## Docket No. 272 - Development and Management Plan Inspection

## **Beseck Switching Station Inspection**

Date: February 6, 2007

Location: Beseck Switching Station

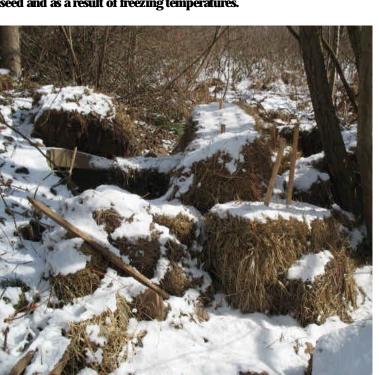
View of Carpenter Lane and retaining walls. Sand accumulation was noted along the gutters from town plows and sanders but is not a result of the project. Gutter buddies were removed from the catch basins during plowing but liners are in place.
